Application for Licence Amendment

Licence Number	L7750/2001/10
Licence Holder	Evolution Mining (Mungari) Pty Ltd
ACN	002 124 745
File Number	2011/009482-1
Premises	Mungari Gold Project COOLGARDIE WA 6429 Legal description – Part mining tenements M15/829, M15/830, M15/1741, M15/1408, M15/1287, M15/688, L15/228, L15/246, L15/227 and M15/1407
Date of Report	05/09/2024
Decision	Revised licence granted

On 07 June 2024, the Licence Holder submitted an application to the department to amend Licence L7750/2001/10 under section 59 and 59B of the *Environmental Protection Act 1986* (EP Act). The amendment is to add the TSF Cell 4 Stage 2 lift constructed under works approval W6364/2020/1 on to the Licence.

Figure 2: Monitoring Bores Standing Water Level results

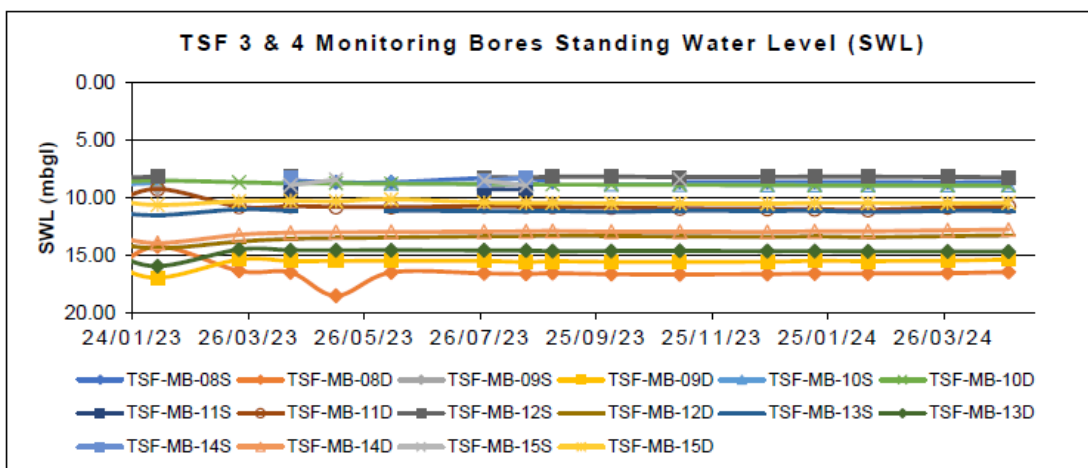
The Licence Holder provided the latest monitoring results for the TSF (Evolution Mining 2024). The Standing Water Level in all monitoring bores were within the licence limit of 4 mbgl as per Figure 2.

As can be observed in the previous figures, parameters levels are overall stable and are within the corresponding limits where they apply.

Figure 3: TSF Cell 3 and TSF Cell 4 TDS results

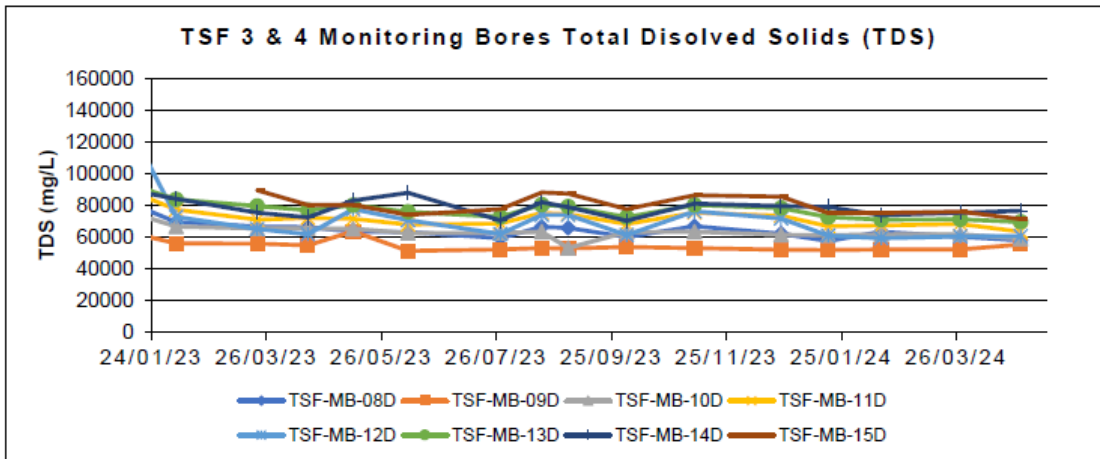
The Total Dissolved Solids (TDS) monitoring results are provided in Figure 3 below:

Figure 4: TSF Cell 3 and TSF Cell 4 electrical conductivity

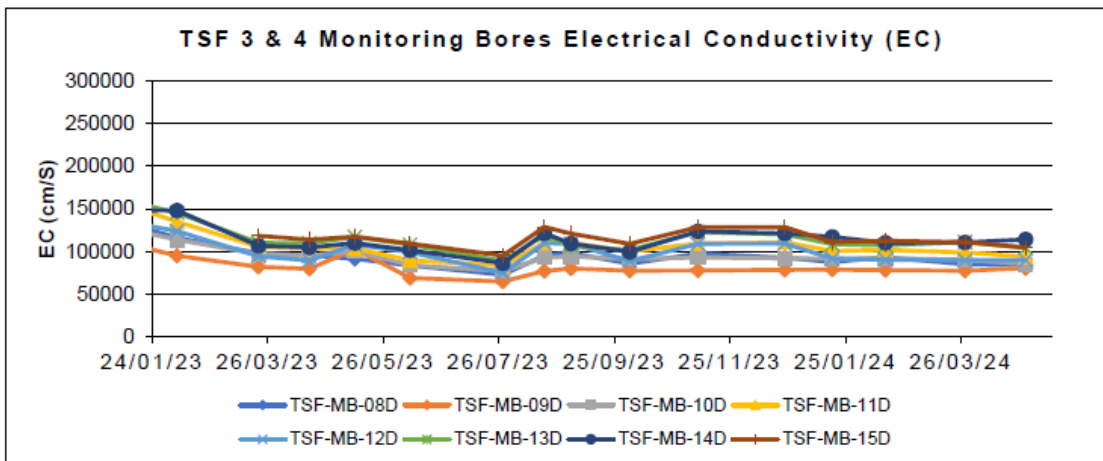
The Electroconductivity results are provided in Figure 4 below:

Figure 5: TSF Cell 3 and TSF Cell 4 pH levels

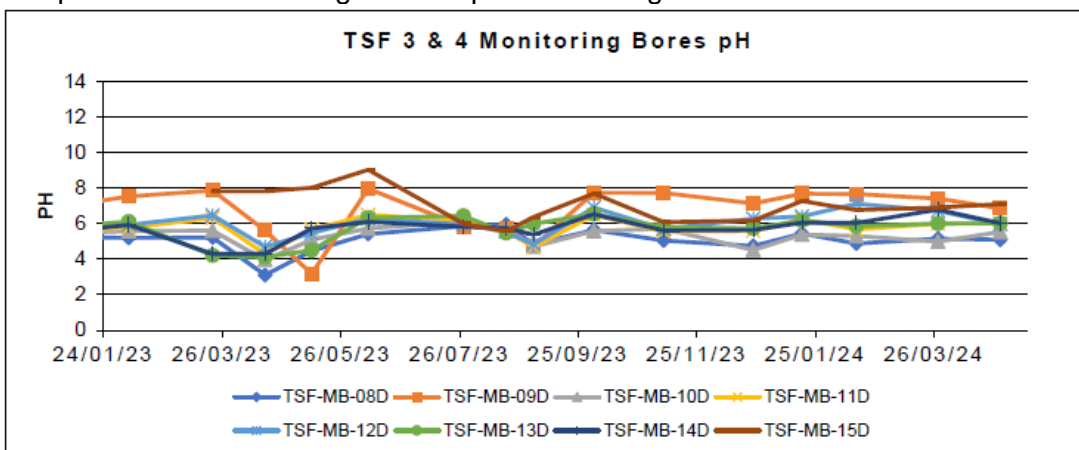
The pH level for monitoring bores is provided in Figure 5 below:
